Re: Response to Comments
Twin Pines Minerals, LLC Permit Coordination Document
Mine Name: Saunders Demonstration Mine
County: Charlton

Twin Pines Minerals, LLC (TPM) has reviewed the Twin Pines Permit Coordination Document provided by the EPD, dated April 14, 2021, and offers the following responses. Each comment is repeated below, followed by TPM's response.

FIGURE 1: FLORIDAN AQUIFER PUMPING WELL DRAWDOWN MAP
TWIN PINES MINERALS, LLC SAUNDERS DEMONSTRATION MINE (ID NO. 2073)

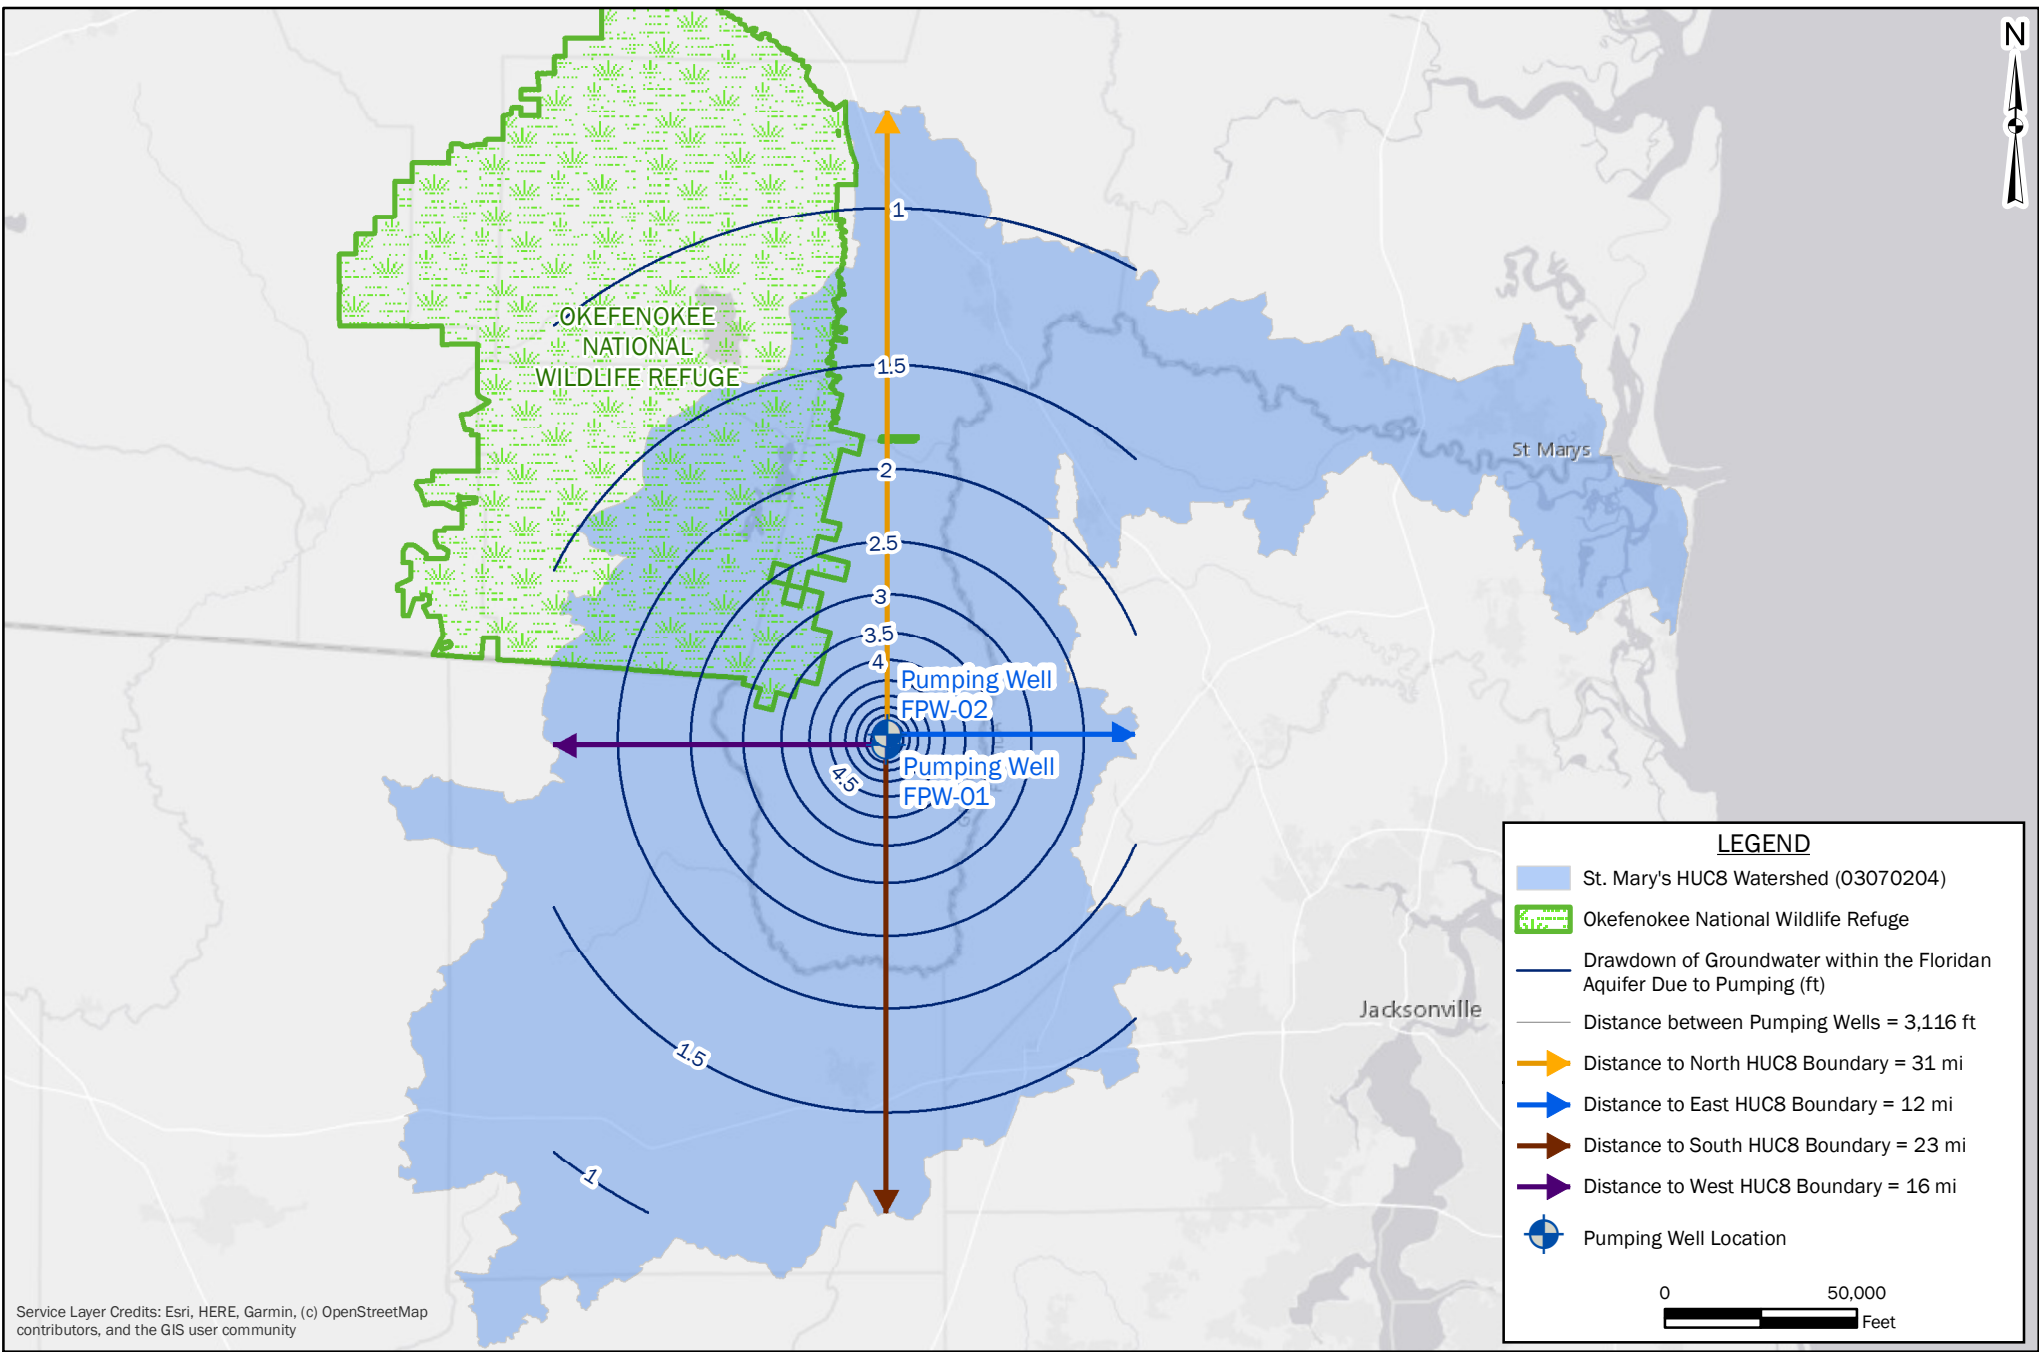
- iv. *Water Supply - State how the proposed withdrawal is compared to the production capacity of the Floridan Aquifer. Also provide the distance to the nearest known supply well, public or private, completed in the Floridan Aquifer. Will withdrawal from the Floridan Aquifer create a cone of depression that may impact nearby watersheds? If so, this data needs to be provided or pointed to within the MLUP.*

Response: TPM conducted an analysis of the effects of withdrawal from the Floridan Aquifer. This analysis is documented in Attachment A of this document. A summary of the results of the analysis is also provided in the checklist explanations document.

Based on the well inventory prepared for the project, there are no public water supply wells in the area. The nearest known public water supply well completed in the Floridan Aquifer is located in Folkston, Georgia, approximately 22 miles northeast of the proposed Saunders Demonstration Mine Site. To the best of our knowledge, the nearest known private water supply well completed in the Floridan Aquifer is located at the Martin Marietta Materials – St Marys Sand Company, approximately 11 miles southeast of the proposed Saunders Demonstration Mine Site. Based on our review of readily available published information, there are four permitted water supply wells installed within the Floridan Aquifer in Charlton County, Georgia (see Table 1).

Three of the four water supply wells installed within the Floridan Aquifer are within the St Marys River Basin and one well is within the Satilla River Basin (Table 1). To compare the production capacity of Floridan Aquifer to the proposed withdrawal at the proposed Saunders Demonstration Mine Site, we evaluated the approved permitted withdrawal limits of the four permitted water supply wells to the proposed withdrawal rate at the mine site. The proposed withdrawal rate at the proposed mine site (1.44 million gallons per day (MGD)) is generally consistent with the permitted monthly withdrawal limit for the City of Folkston (1.50 MGD) and within the production capacity of the Floridan Aquifer.

The MATLAB code requires an estimate of T and S for the Floridan Aquifer. Williams and Kuniandy (2016) report T and S values for 11 wells in the upper Floridan Aquifer. One well had an anomalously low T value and was excluded from our analysis. The T and S values for the remaining 10 wells were averaged to define the values of T and S used here (Table 2). The predicted drawdown at the proposed production wells after 4 years of pumping at the TPM site is shown in Figure 1. These results indicate that the basin north of the St. Marys River Basin will see drawdown of less than 1 foot due to TPM pumping, the basins south and west of the St. Marys River Basin will have drawdown between 1 foot and 2 feet, and the basin east of the St. Marys River Basin will show drawdown of slightly over 2 feet.
